**GARVEY COMMONS/ SHERBURNE HALL**  
ADDITIONS & REMODELING  
ST. CLOUD STATE UNIVERSITY  
ST. CLOUD MINNESOTA

REVISED	PROJECT NO. 86015
	ISSUE DATE 12-15-66
	DRAWN BY FEW
	CHECKED HV
	APPROVED ARCHITECT FW
	SCALE AS SHOWN

**GARVEY COMMONS FIRST FLOOR PLAN**  
SCALE 1/8"=1'-0"

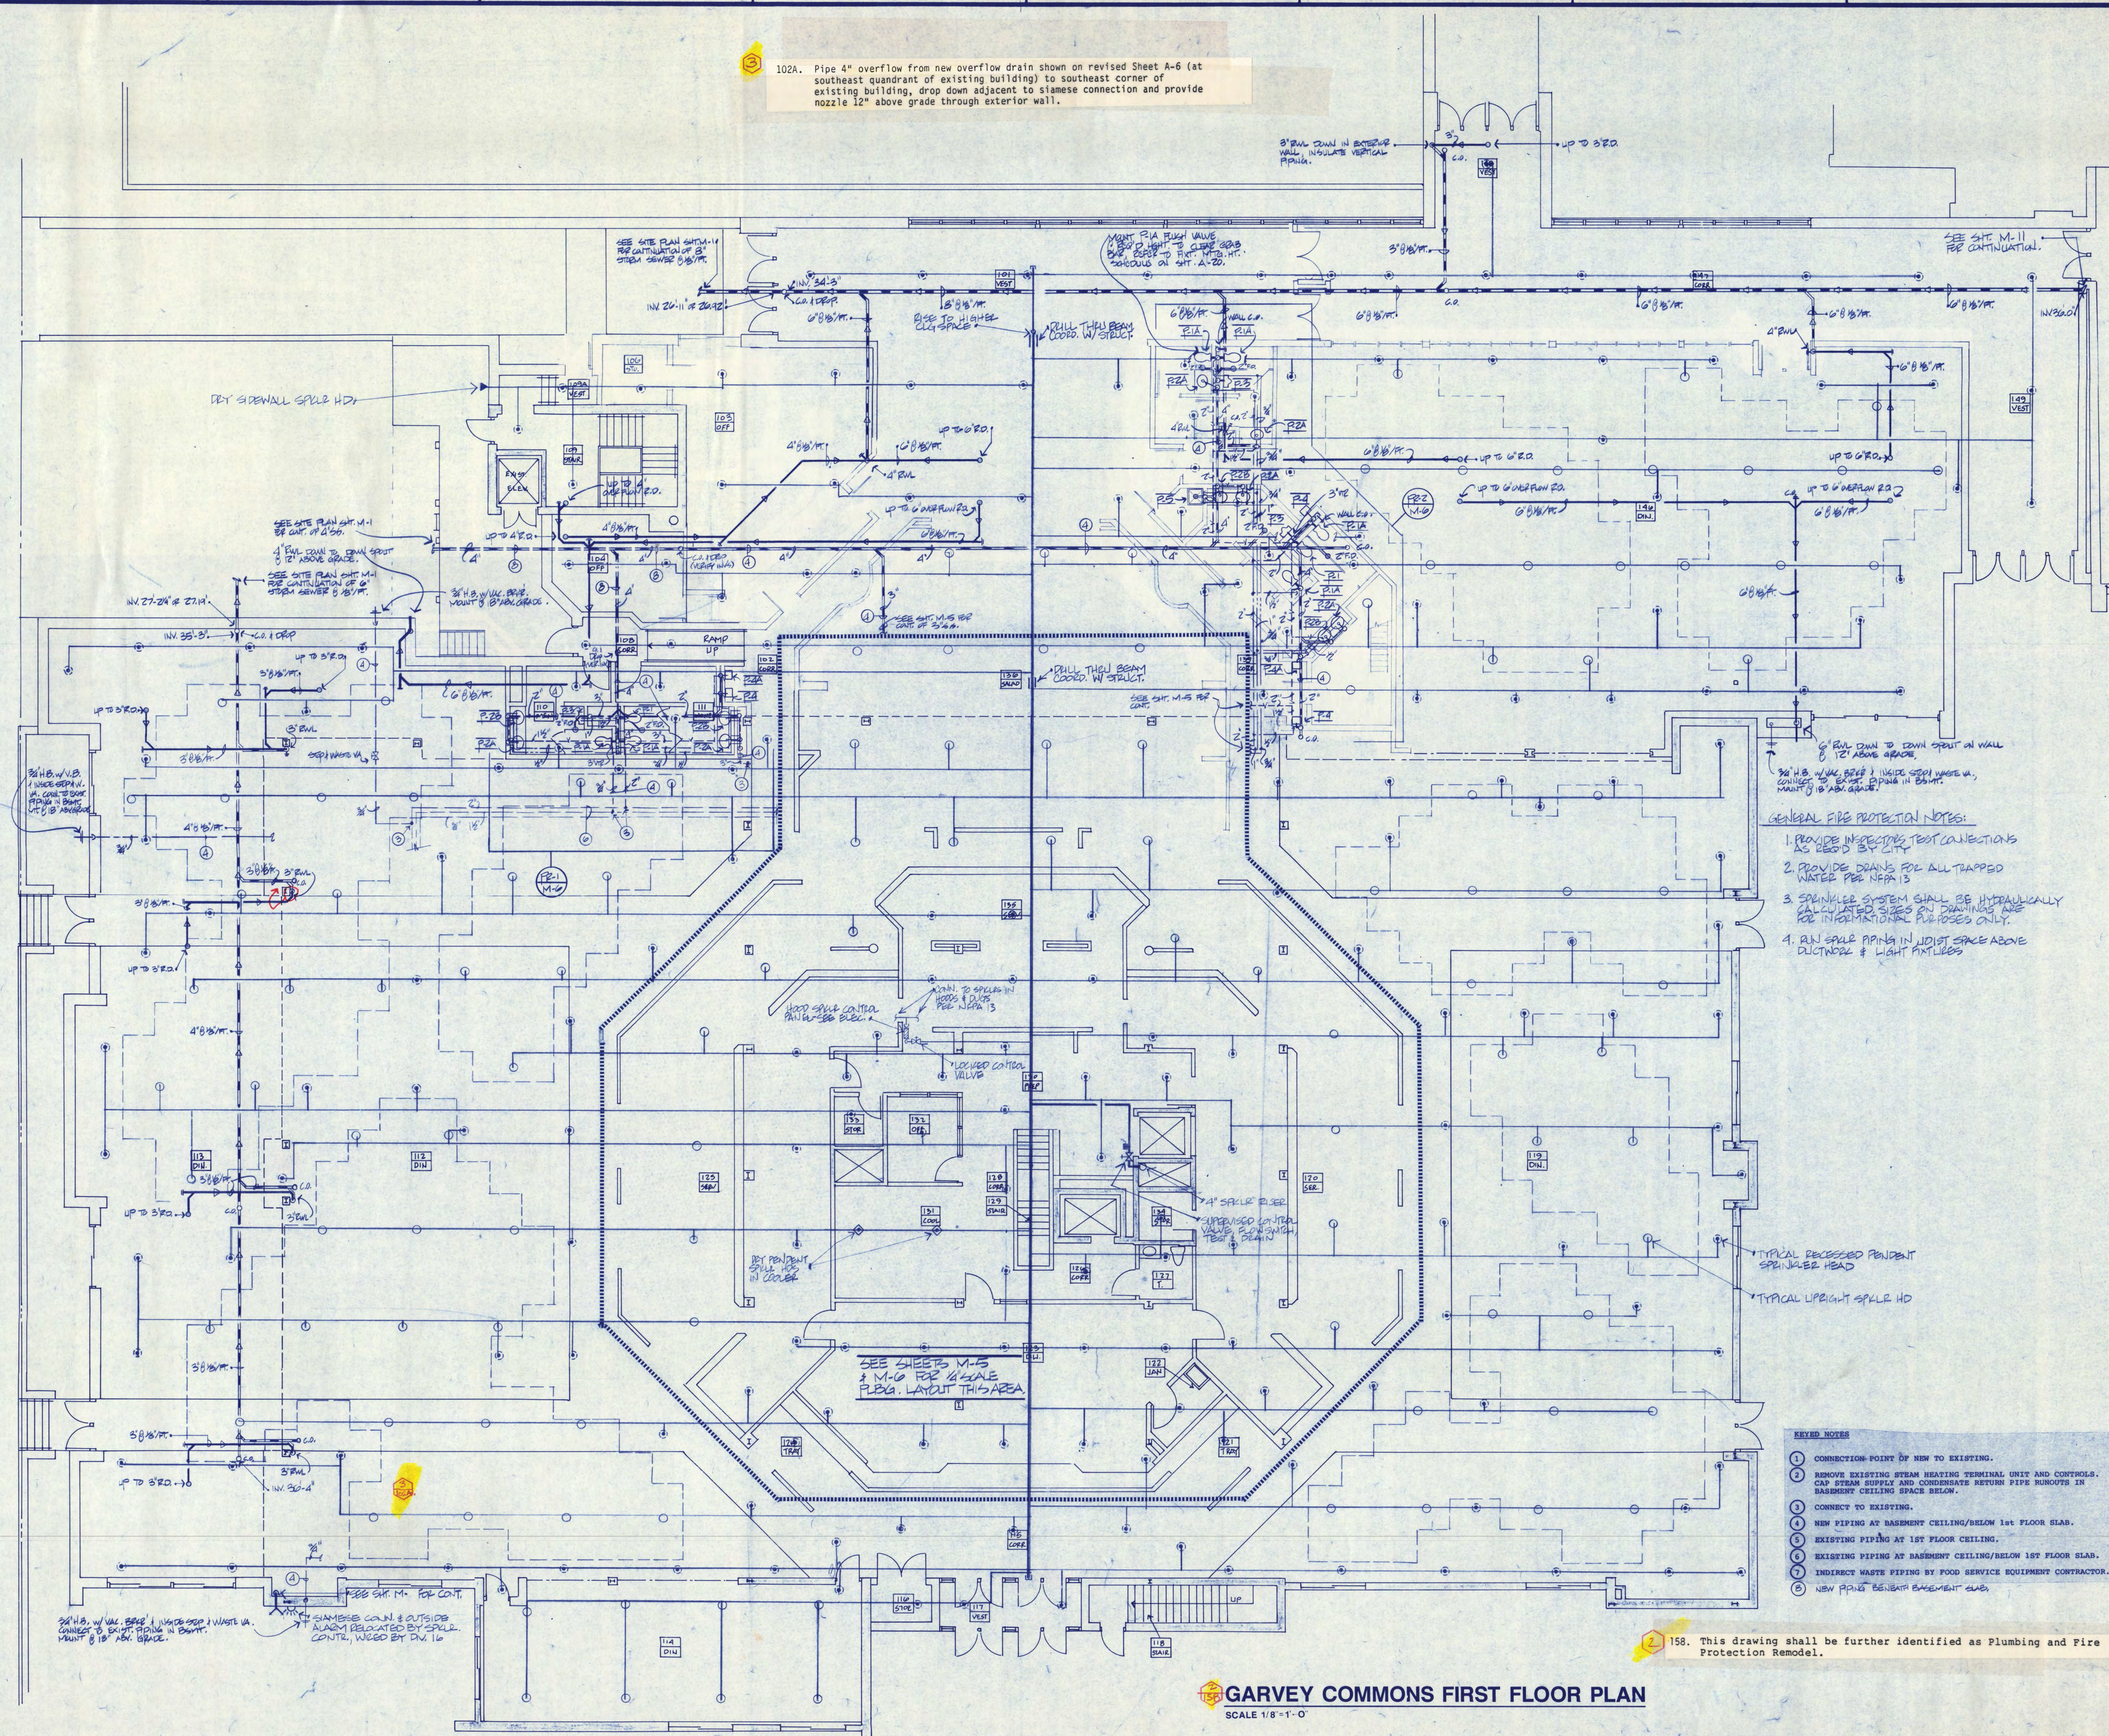
102A. Pipe 4" overflow from new overflow drain shown on revised Sheet A-6 (at southeast quadrant of existing building) to southeast corner of existing building, drop down adjacent to slimes connection and provide nozzle 12" above grade through exterior wall.

158. This drawing shall be further identified as Plumbing and Fire Protection Remodel.
